# CITY OF ALBUQUERQUE

Planning Department  
Brennon Williams, Director

## DRAINAGE AND TRANSPORTATION INFORMATION SHEET (REV 6/2018)

**Project Title:** 11906 SAN ANTONIO **Building Permit #:** \_\_\_\_\_ **Hydrology File #:** \_\_\_\_\_  
**DRB#:** \_\_\_\_\_ **EPC#:** \_\_\_\_\_ **Work Order#:** \_\_\_\_\_  
**Legal Description:** LOT C-2-A-1 SAUVIGNON SUBDIVISION  
**City Address:** 11906 SAN ANTONIO

## DRAINAGE NARRATIVE

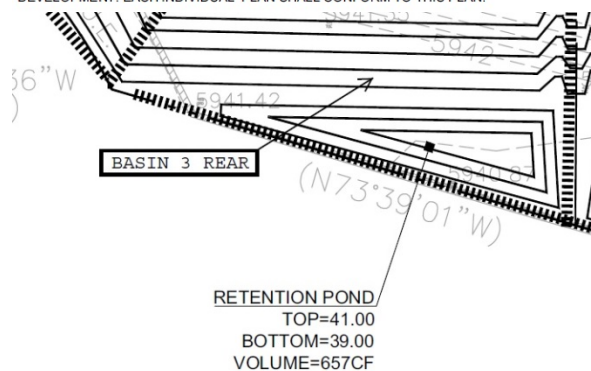
- Per the approval letter for Prichard Subdivision dated December 17, 2018 (Attached), Hydrology will need written permission from PNM for any grading within their 65 feet Easement.
- Also according the approved Conceptual Grading & Drainage Plan for Prichard Subdivision (E22D007H), a retention pond is required to hold the 100yr-6hr storm. (See Below) Therefore this lot needs a retention pond volume of 657 CF.

- The proposed drainage narrative provided violated this previous approved Conceptual Grading & Drainage Plan for Prichard Subdivision. (See Below) Therefore this will have to conform with this plan.
